April 1, 2019

ADDENDUM NUMBER 1
TO THE DRAWINGS AND SPECIFICATIONS

PROJECT: Edison Elementary School 2019 Addition

A/E PROJECT NO: 2275 0217

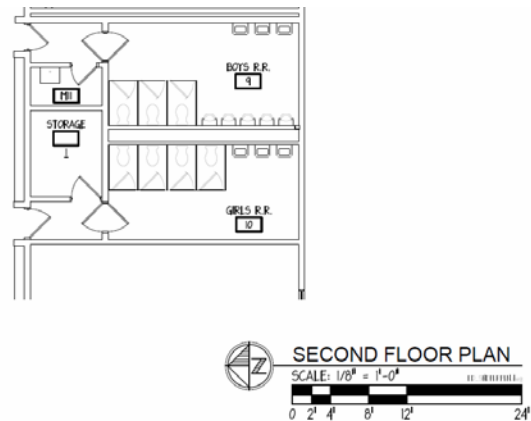
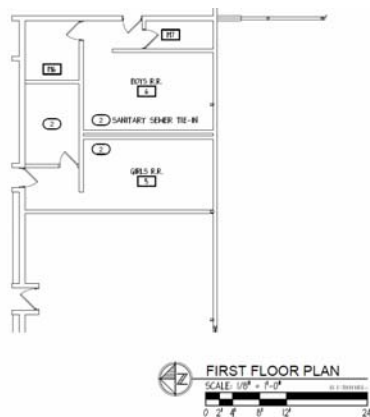
Item 1A: Disposer approved equal Insinkerator SS-200 and control center
Insinkerator AS-101

Item 11: Refrigerator approved equal Arctic Air AR 49

Item 12 Freezer approved equal Arctic Air AF 49
